# Access Compliance Report

## Public Rights-of-Way

Intersection ID: 14706	Main Street: FULLIGER_ST	Cross Street: HIRAM_ST	Location: SW
ADA ID: F68487FD8F0F	Ramp Type: PerpDiag	Initial Pass/Fail: Fail	Overall Compliance: No
Severity Score: 42.5			
Codes/Mitigation Info/Possible Solution		Field Measurements/Component Compliance

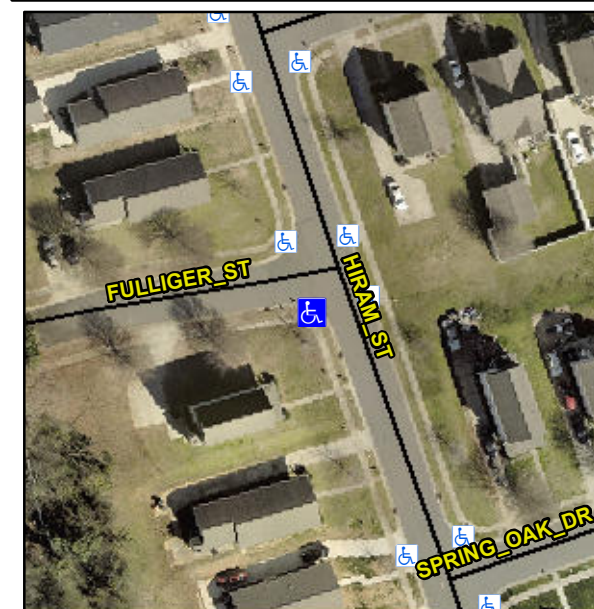
**Not Found, R304.5.1, R304.5.3**

Compliance	Description	Data	Compliance	Description	Data
N/A	Ramp Length (in)	95.0	Yes	Ramp Slope (%)	5.6
No	Ramp Width (in)	34.0	No	Ramp XSlope (%)	9.0
N/A	Flare Type LT	N/A	N/A	Flare Type RT	N/A
N/A	Flare Slope LT (%)	N/A	N/A	Flare Slope RT (%)	N/A
N/A	Flare Traversable LT?	N/A	N/A	Flare Traversable RT?	N/A
N/A	Landing Length (in)	N/A	N/A	DWS Provided?	N/A
N/A	Landing Width (in)	N/A	N/A	DWS Contrast?	N/A
N/A	Landing Slope (%)	N/A	N/A	DWS Length (in)	N/A
N/A	Landing X Slope (%)	N/A	N/A	DWS Full Width?	N/A
N/A	Landing Curb? (Y/N)	N/A	N/A	DWS Offset (in)	N/A
N/A	Shared Landing?	N/A			
N/A	Gutter Ponding?	N/A	N/A	Gutter Slope (%)	N/A
N/A	Gutter Lip Ht (in)	N/A	N/A	Gutter X Slope (%)	N/A
N/A	Painted X Walk1?	No	N/A	Painted X Walk2?	No
	X Walk 1 Direction	To E		X Walk 2 Direction	To N
N/A	X Walk 1 Width (in)	N/A	N/A	X Walk 2 Width (in)	N/A
	X Walk 1 Slope (%)	0.6		X Walk 2 Slope (%)	7.9
	X Walk 1 X Slope (%)	5.8		X Walk 2 X Slope (%)	3.0

**Remove & Replace Curb Ramp With Two New Directional Ramps or Equivalent.**
